Re: Cherokee Nation WW Hastings Replacement Hospital - Addendum 02 Narrative

Following is a list of revisions included in Addendum 02.

PROJECT PHASE:
BID PACKAGE 02
(SITE DEMOLITION AND UTILITIES)

11/18/2022 A:\2021\5123.21\03_DSGN\01_DWG\050_CIVIL\07-WATR-5123.DWG

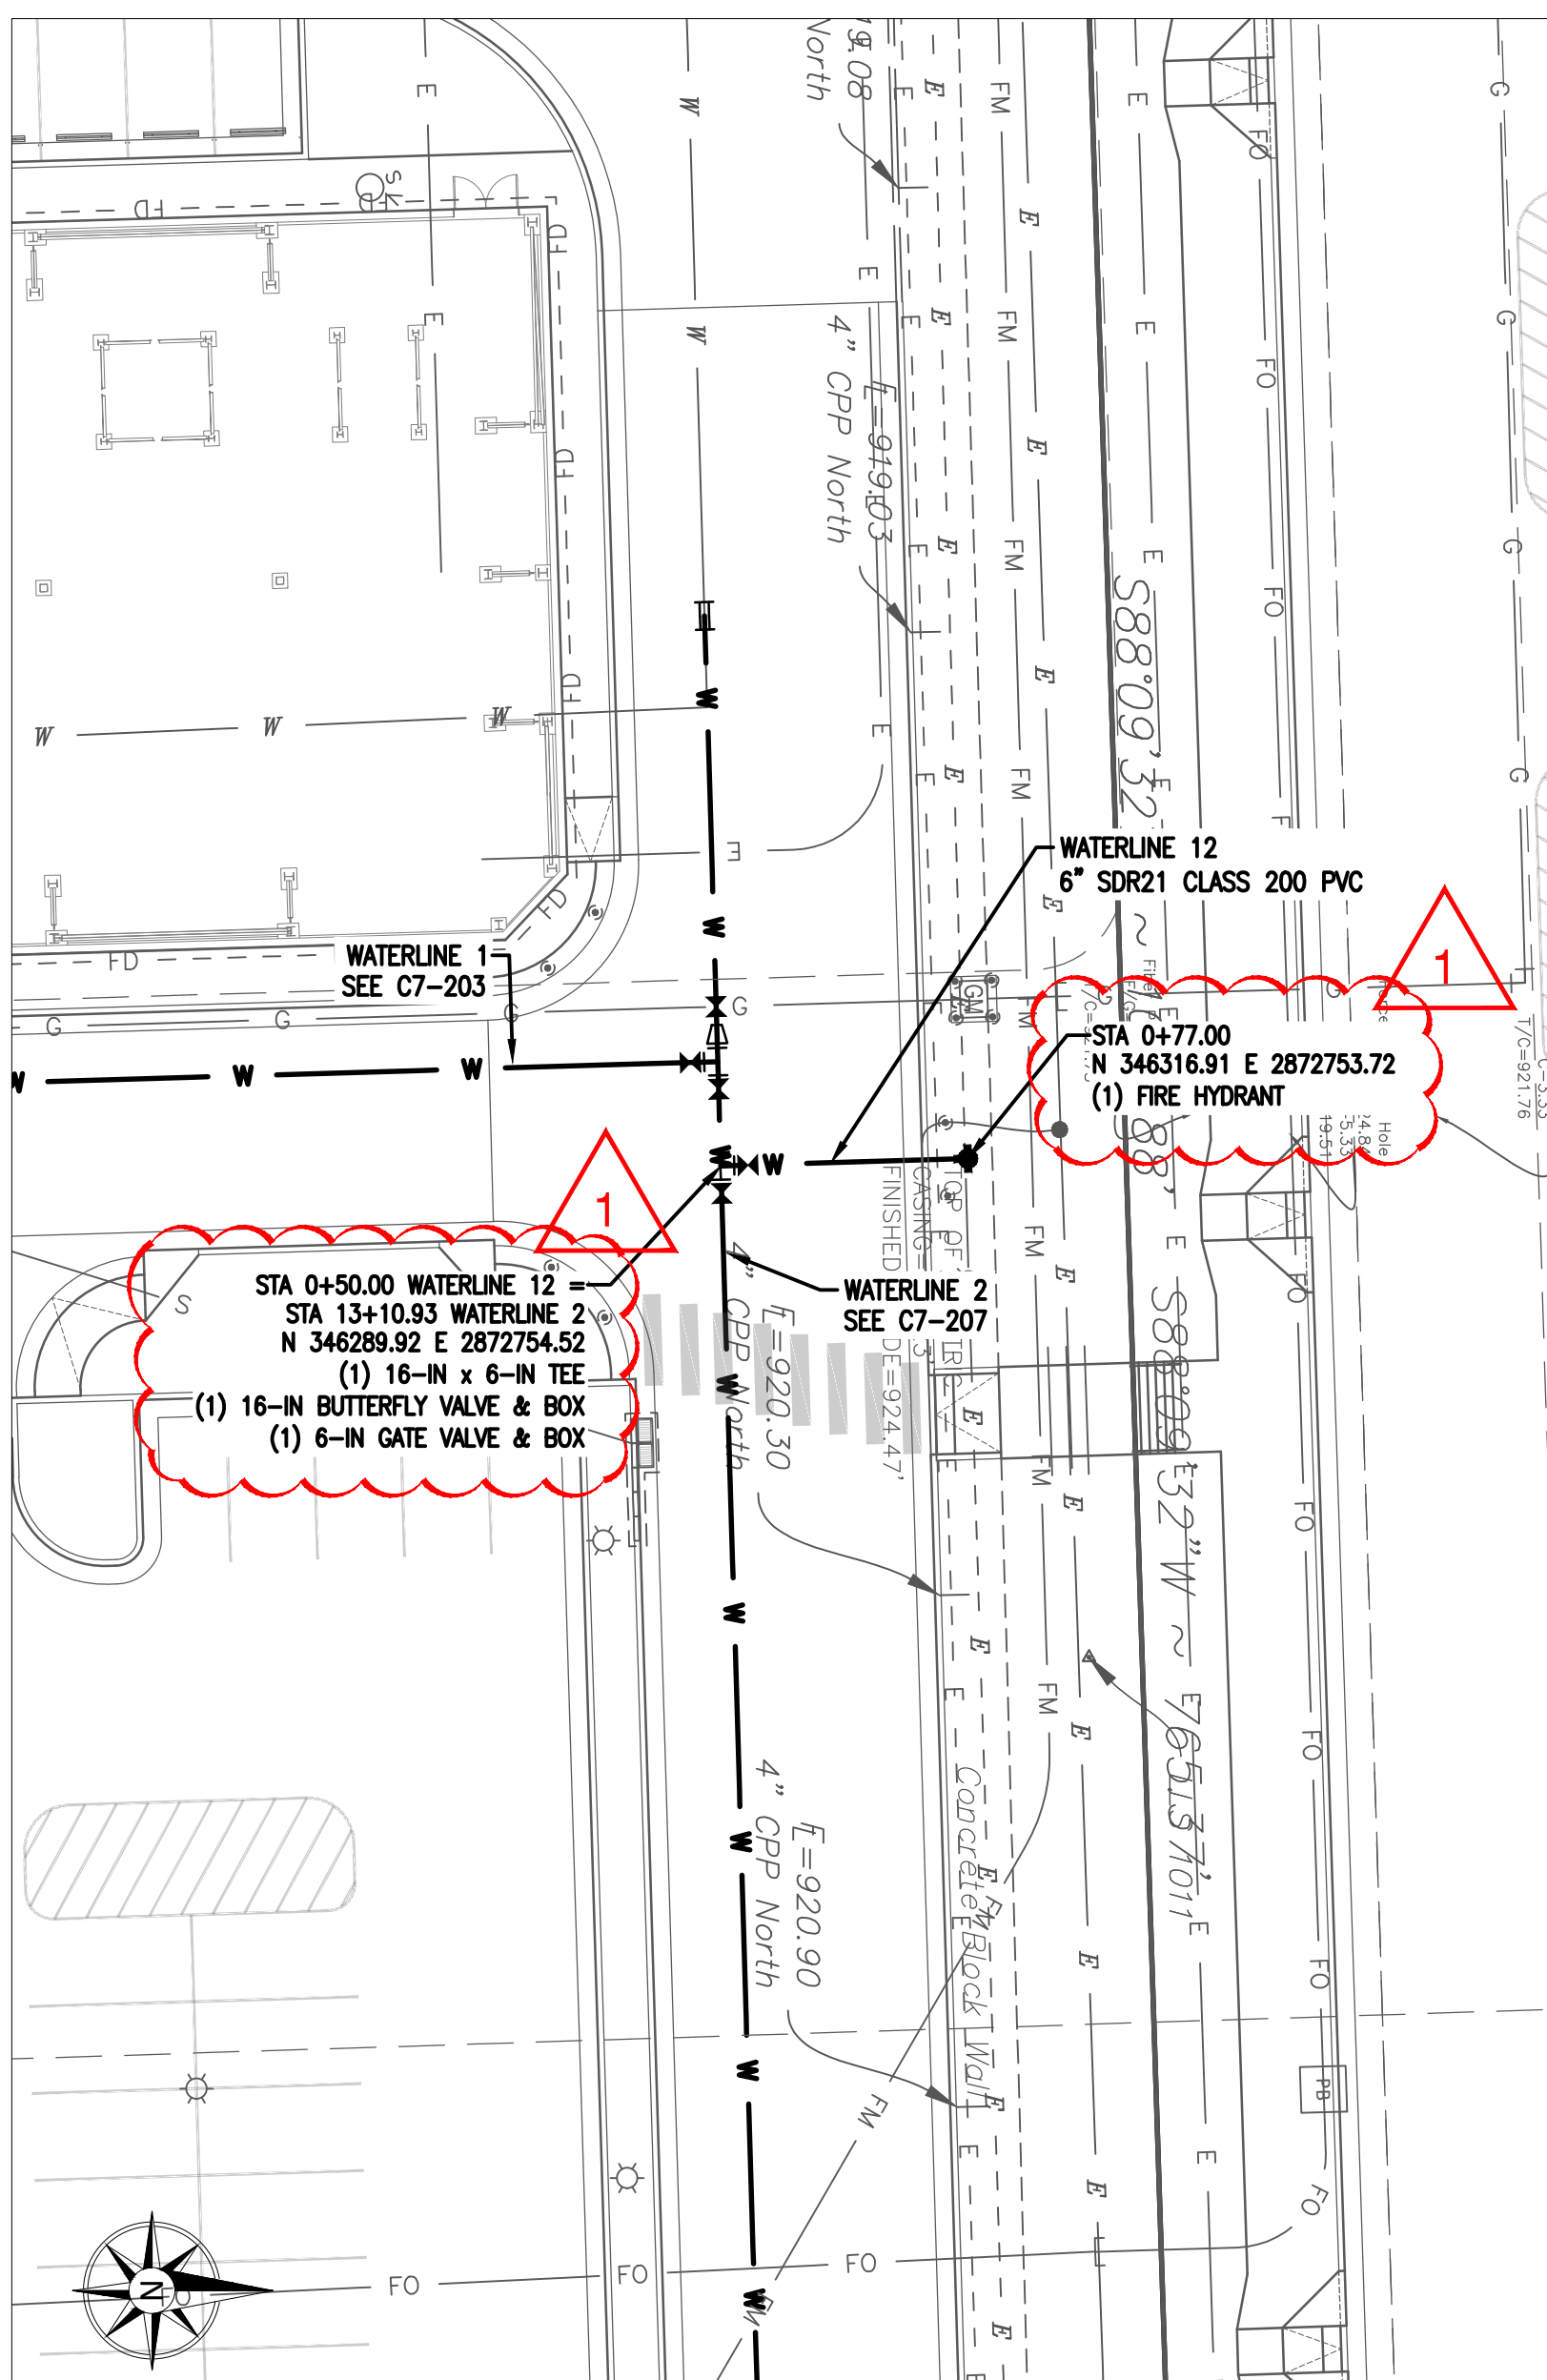
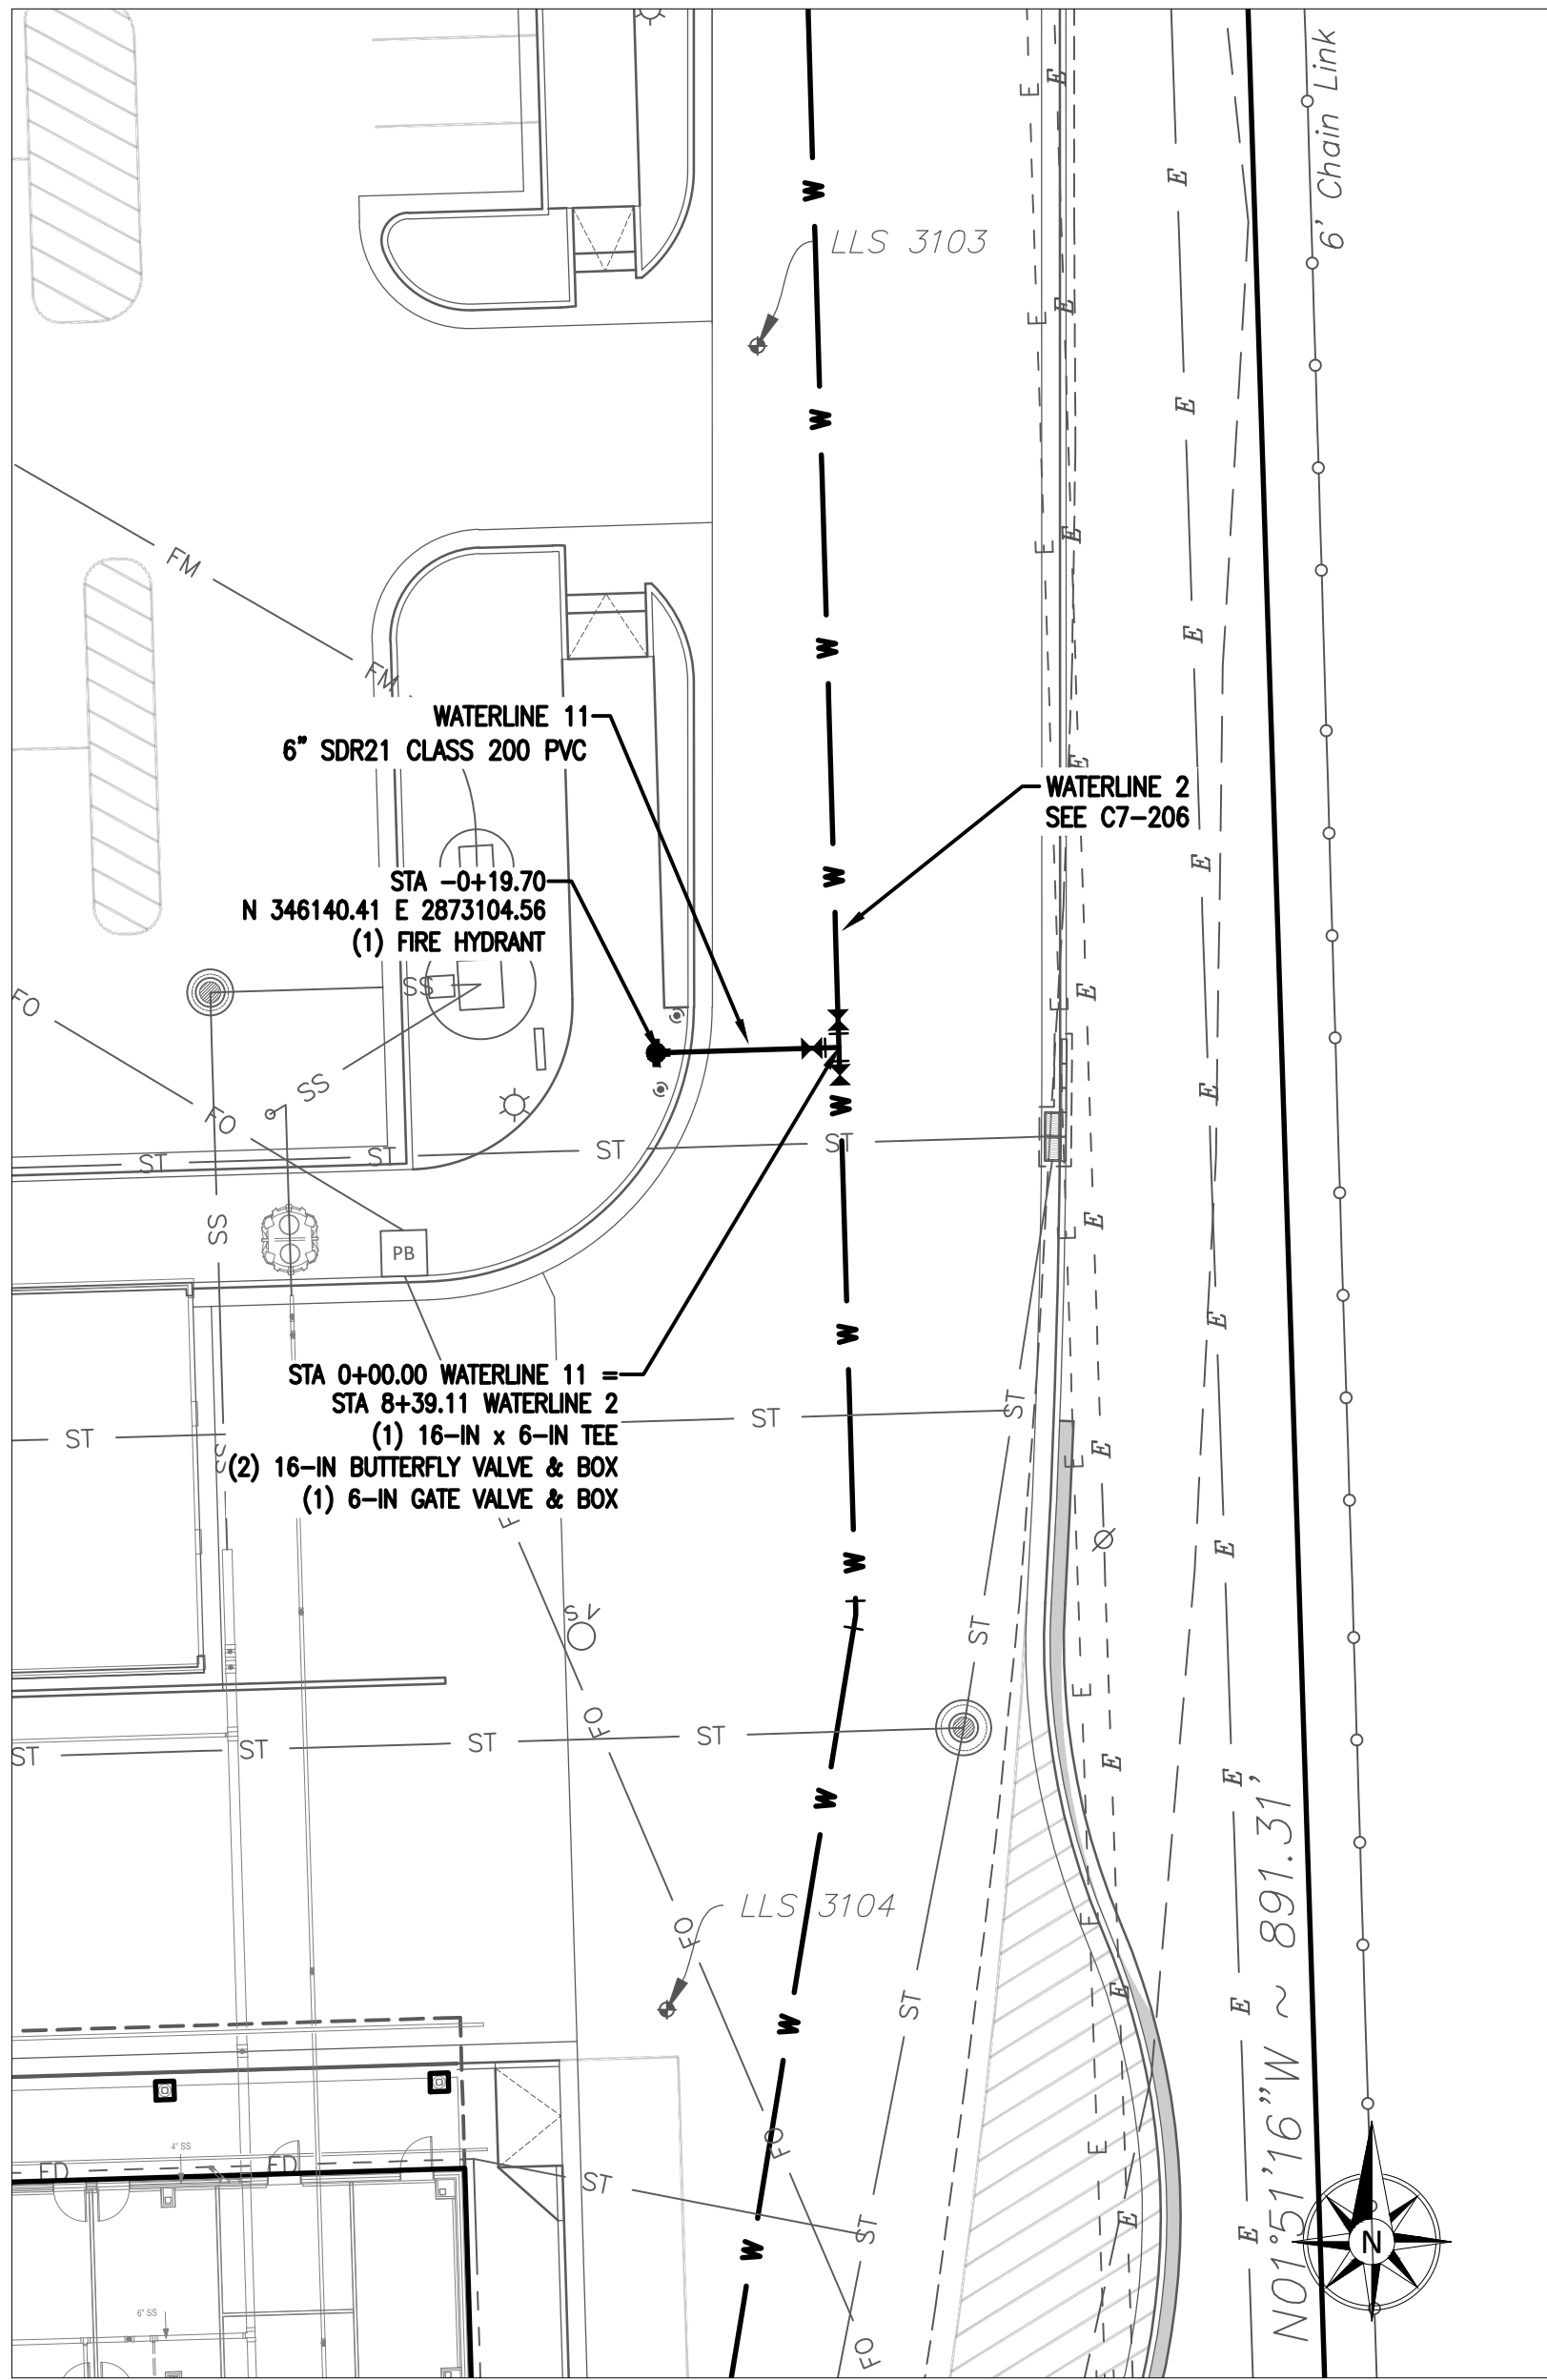
- C7-214 - Added call-outs to the material in the plan view of Water 12.
